REVIEW OF DEPARTMENT OF INTERIOR METHODOLOGY FOR ASSESSMENT
OF UNDISCOVERED OIL AND GAS RESOURCES INCLUDING ADDENDUM,
NRC COMMENTS, AND CNWRA RESPONSE TO COMMENTS

CNWRA Report No. 3702-002-305-303

May 30, 1990

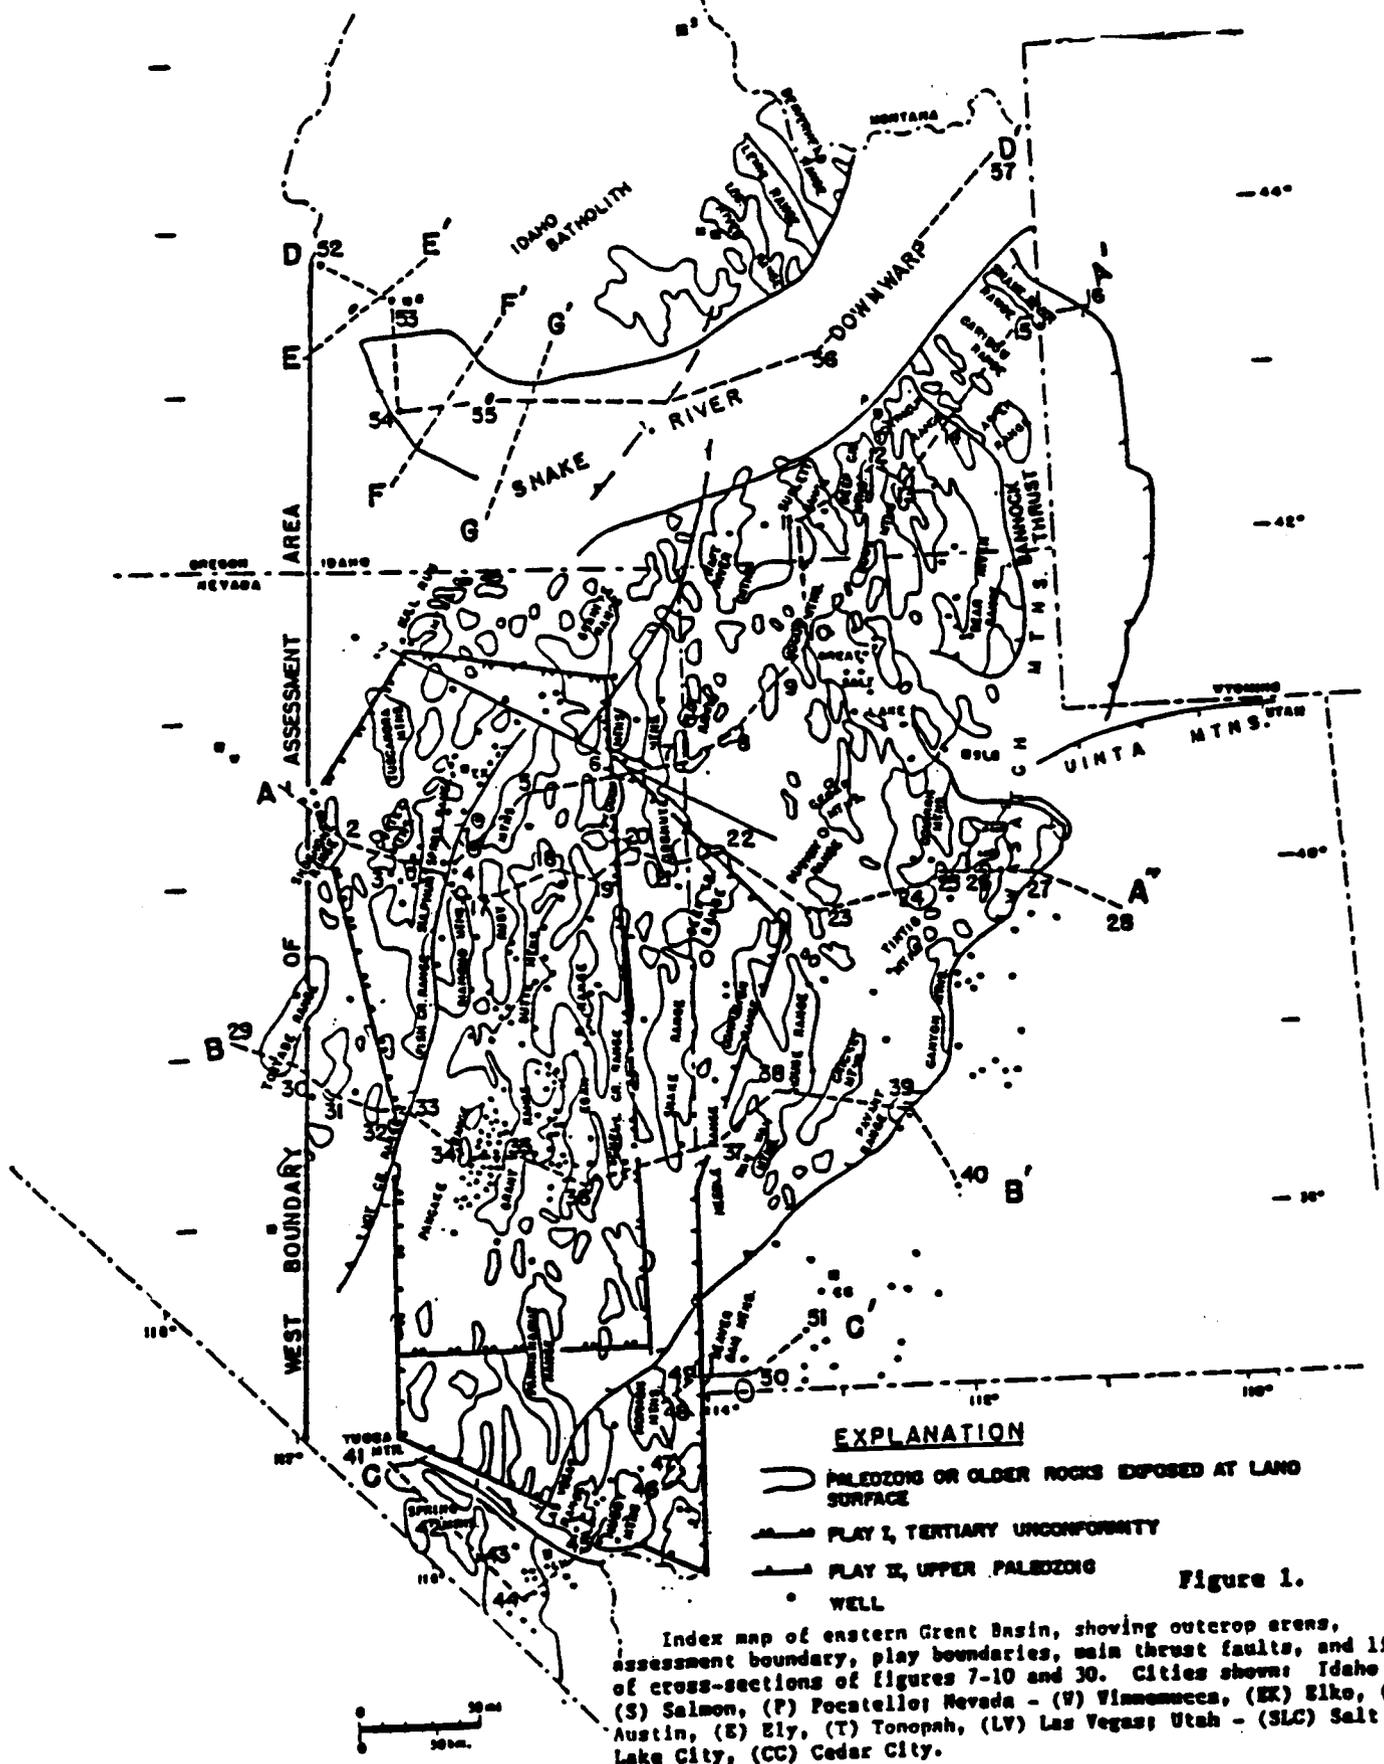
Page 2 Comment (1) "Discuss the impact of the given estimates on the Yucca Mt. site. Is it in a favorable area so far as the USGS is concerned? Does the report give the impression that the prospects look good for hydrocarbon exploration and discovery?"

Page 5 Comment 3. "Are any plays identified in the Yucca area?"

In Nevada, the USGS identified 2 plays among the 250 in the U.S. Both plays are in the eastern Great Basin: Play I, Tertiary unconformity and Play II, upper Paleozoic. Figure 1 in Attachment A provides the outlines of each play. The border of play II passes about 10 miles northeast of Yucca Mountain; thus, Yucca mountain is close to, but outside, the play.

Page 5 Response 3. Yucca Mountain is about 10 miles outside the boundary of Play II, lower Paleozoic and about 30 miles outside the boundary of Play I, Tertiary unconformity (Appendix A, p.2).
